**BEFORE THE
PENNSYLVANIA PUBLIC UTILITY COMMISSION**

Petition to Approve)	
Act 129 Phase III Efficiency)	
And Conservation Program)	Docket Number. M-2015-2515375
for Duquesne Light Co.)	
)

**COMMENTS OF JOINT COMMENTATORS: PENNFUTURE, SIERRA CLUB,
ENVIRONMENTAL DEFENSE FUND, KEYSTONE ENERGY EFFICIENCY
ASSOCIATION, AND CLEAN AIR COUNCIL**

The plan should provide more support for upstream measures

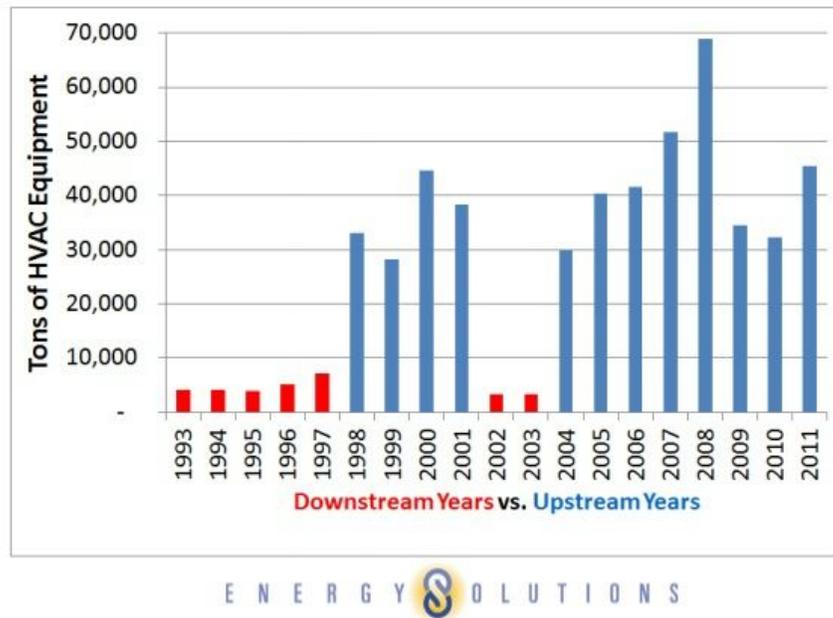
The proposed plan's residential energy efficiency program (REEP) relies on rebates to motivate customers to replace appliances.⁷ Reliance on downstream measures like rebates compromises the effectiveness and cost effectiveness of programs because many consumers neglect to pursue rebates or consider them as part of their purchasing decision,⁸ and manufacturers and distributors, in turn, do not see the market signals associated with these purchases. An upstream, or midstream, approach that results in immediate savings at the point of sale "more effective because a small number of manufacturers and distributors are in a position to impact a larger magnitude of decisions to purchase and install high efficiency equipment."⁹ The table below dramatically illustrates the relative success of upstream programs compared to rebates on HVAC systems installed in California between 1993 and 2011.¹⁰ While this shows results from a California program, there is no reason to believe the outcome in Pennsylvania would be substantially different.

We recommend that the plan be revised to pursue upstream measures for residential programs.
